BORDER FORTS  
NUMBERED 602, 604,  
628, AND 634  
SULAYMANIYAH, IRAQ

**SIGIR PA-05-021**

SUBJECT: Report on Project Assessments of Border Forts Numbered 602, 604, 628, and 634 in Sulaymaniyah, Iraq (Report Numbers SIGIR PA-05-021, PA-05-022, PA-5-023, and PA-05-024)

## Border Forts Numbered 602, 604, 628, and 634 Sulaymaniyah, Iraq

Site Photo 20. Two Generator Units, Metal Enclosures, and Fuel Tanks (Safrah #634 Border Post)

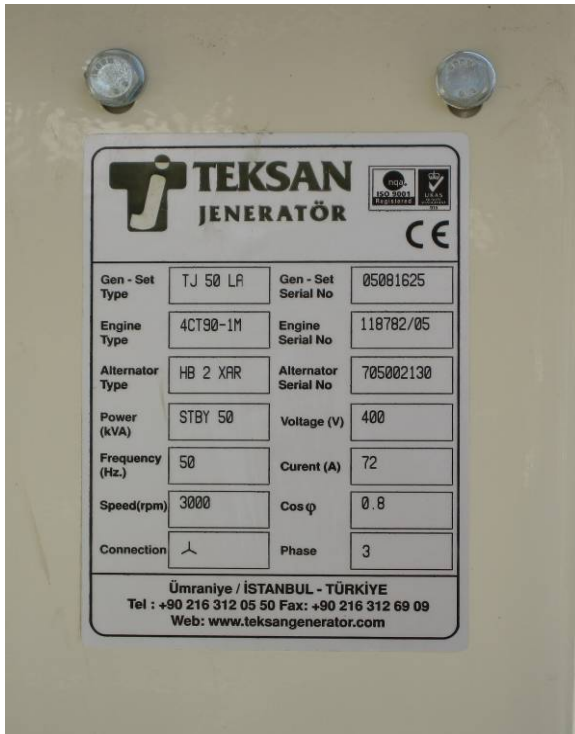
Site Photo 20 shows the two generator units, metal enclosures, and two fuel storage tanks. Site Photos 21 and 22 show the factory nameplates of the generator units.

**Site Photo 30. Front Exterior View of Border Post  
(Marwa #628 Border Post)**

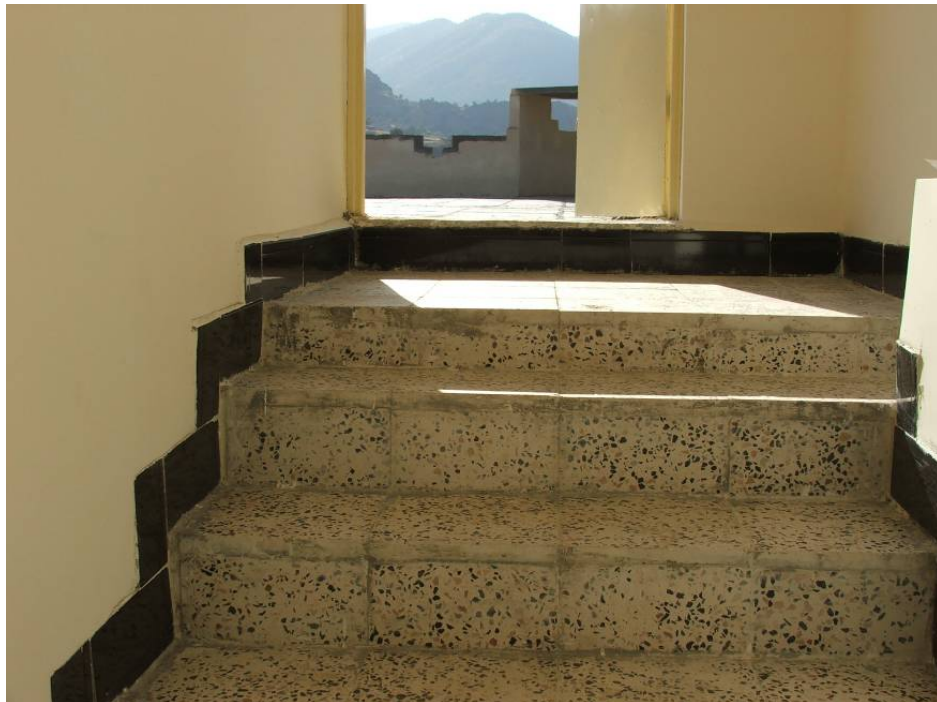
During the site visit, we verified that the facility was completed, that it was constructed with block exterior, and that the electrical systems were installed. Electrical power was not on during the site visit. Site Photo 30 shows the exterior front of the border fort facility and Site Photo 31 shows the roof, parapets, and flagpole.
